11009-22.JVD.319544

RESPONSE TO OFFICE ACTION
Attorney Docket No. 11009-22
Page 11 of 17

U.S. Patent Application No. 10/630,342

Marked Up Page 2 of 4

Fig. 1
(Prior Art)

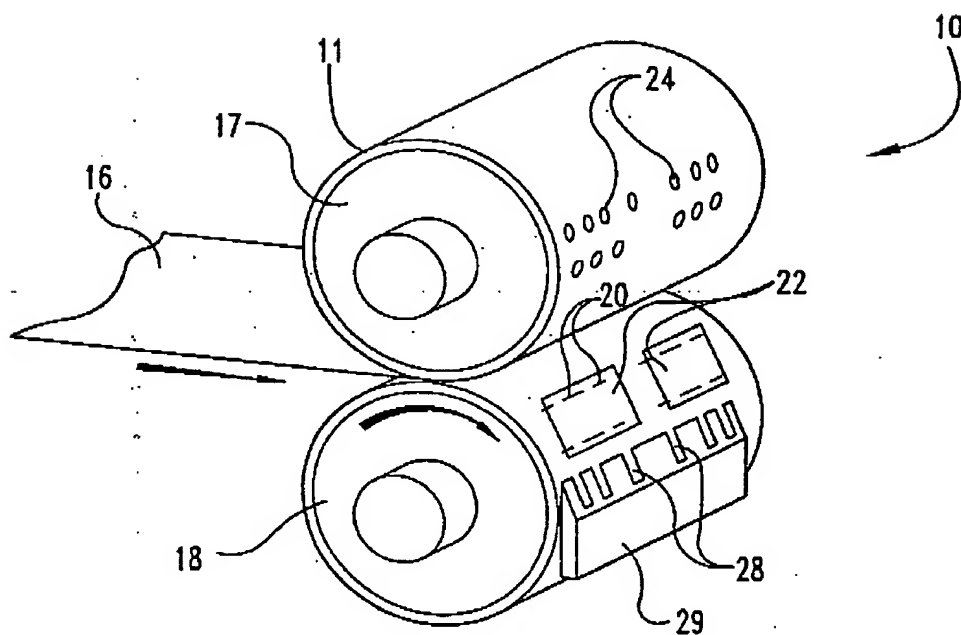
FIGS. 1-5 were objected to for not including a legend such as "Prior Art." Further, FIG. 8 was objected to for an arrow that is in the wrong direction.

Applicant has corrected these errors and provided replacement sheets with this Response. Applicant requests withdrawal of the objection.
